IREDELL COUNTY HEALTH DEPARTMENT

IMPROVEMENT PERMIT AND CERTIFICATE OF COMPLETION / OPERATIONS PERMIT

OWNER OR CONTRACTOR Allen Ronald Jones DATE 1/15/93 PERMIT NO. 9RA-81

Plot of System (Not to Scale)

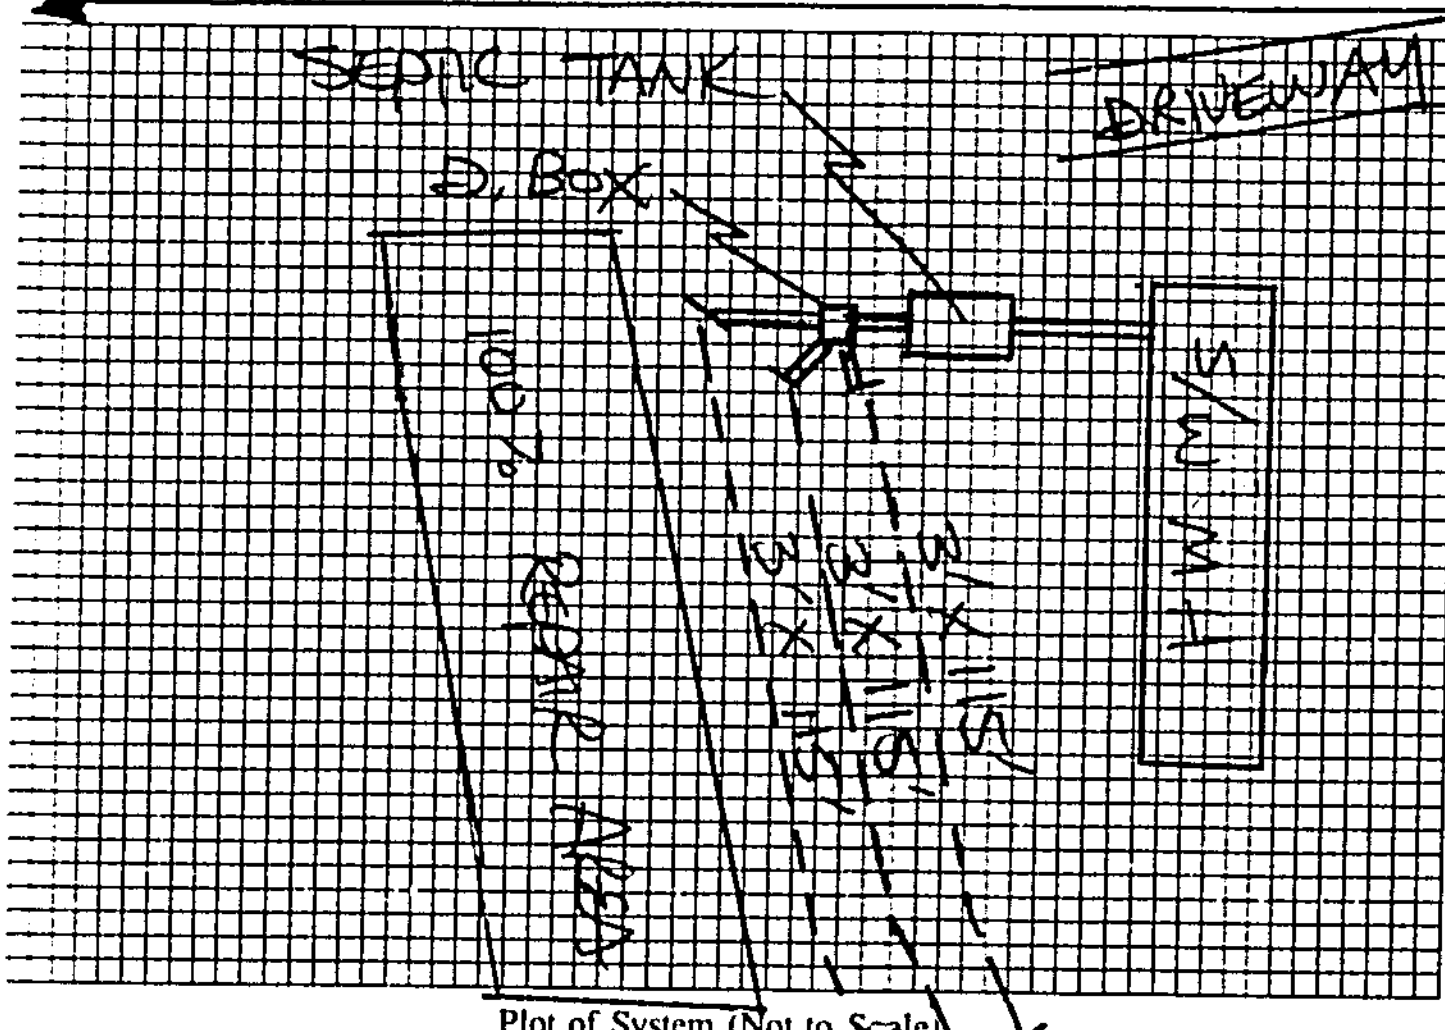
COMMENTS (1) Keep system minimum 5' from MH, 10' from property line, 100' from well, (2) Install lines on contour, no deeper than 36", 9' apart on center; (3) Repair area is 100% conventional, gravity-fed.
